DART AEROSPACE LTD	Work Order:	119708
Description: Crosstube Assembly (205/212 High Aft)	Part Number:	D212-664-241
Inspection Dwg: D212-664-241 Rev: D		Page 1 of 2

DRAWING NO. D212-664-241	TITLE CROSSTUBE ASSY (205/212 HI AFT)	REV. D	DART AEROSPACE LTD ENGINEERING ORDER		D.E.O. NO. D212-664-241-D-1	SHEET NO. SHEET 1 OF 2	SCALE NTS
DRAWN	CHECKED	MFG. APPR.	APPROVED	DE APPR.			
DATE 11.04.07	DATE 11.04.11	DATE 11.04.12	DATE 11/04/12	DATE 11.04.12

**D212-664-241/-241B
ASSEMBLY DETAIL**

DRAWING NO. D212-664-241	TITLE CROSSTUBE ASS'Y (205/212 HI AFT)	REV. D	DART AEROSPACE LTD ENGINEERING ORDER		D.E.O. NO. D212-664-241-D-2	SHEET NO. SHEET 1 OF 1	SCALE NTS
DRAWN <i>q</i>	CHECKED <i>ASS</i>	MFG. APPR. <i>SS</i>	APPROVED <i>MD</i>	DE APPR. <i>MD</i>			
DATE 11.07.15	DATE 11.07.20	DATE 11.07.21	DATE 11.07.21	DATE 11.07.21

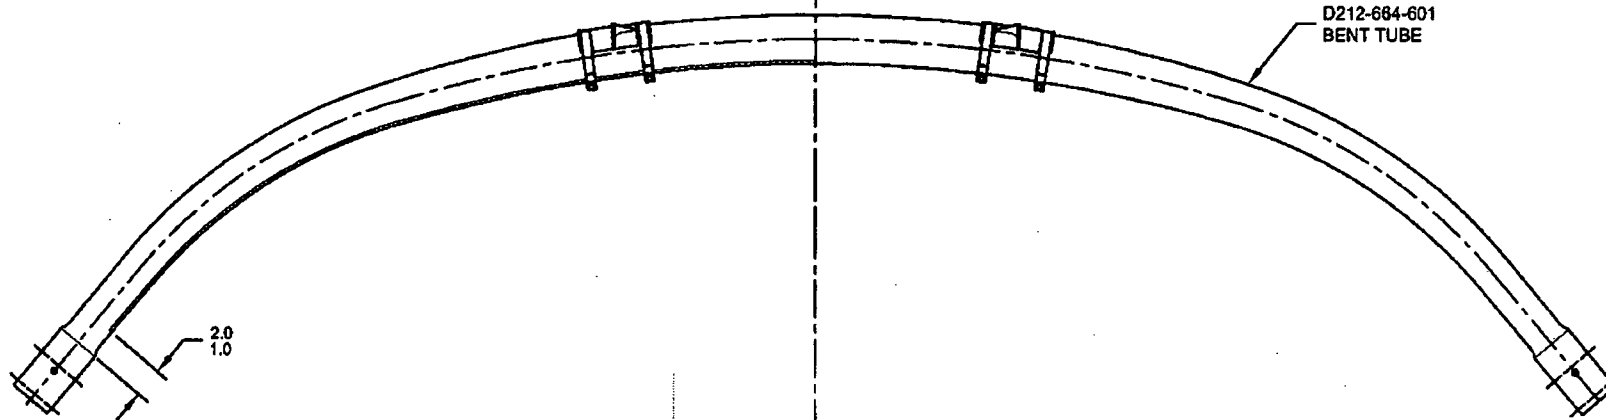
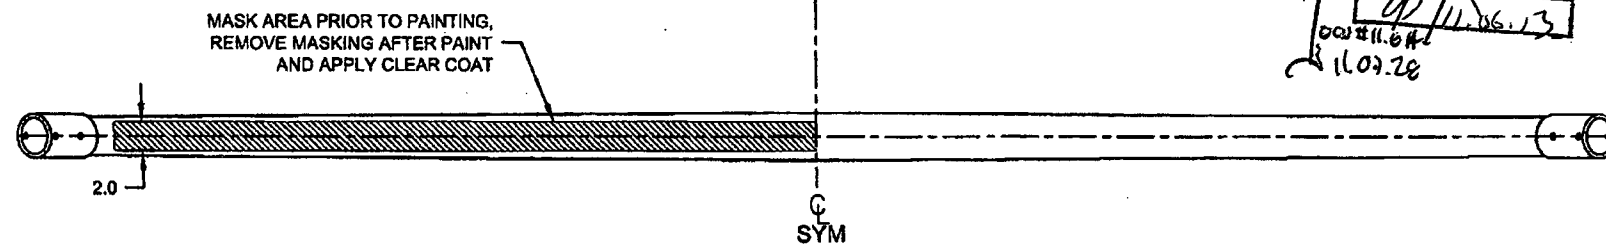
PURPOSE:

ADD AN INSPECTION WINDOW TO UNDERSIDE OF CROSSTUBE.

NOTES 2 OF SHEET 1 IS AMENDED AS FOLLOWS:

IS:

- 2) FINISH: CHEMICAL CONVERSION COAT PER DART QSI 005 4.1
PRIME INSIDE AND OUTSIDE PER DART QSI 005 4.2
MASK UNDERSIDE OF CROSSTUBE AS SHOWN (HATCHED AREA) AND
PAINT OUTSIDE PER DART QSI 005 4.2
REMOVE MASKING AND APPLY CLEAR COAT

WAS:

- 2) FINISH: CHEMICAL CONVERSION COAT PER DART QSI 005 4.1
PRIME INSIDE AND OUTSIDE PER DART QSI 005 4.2
PAINT OUTSIDE PER DART QSI 005 4.2
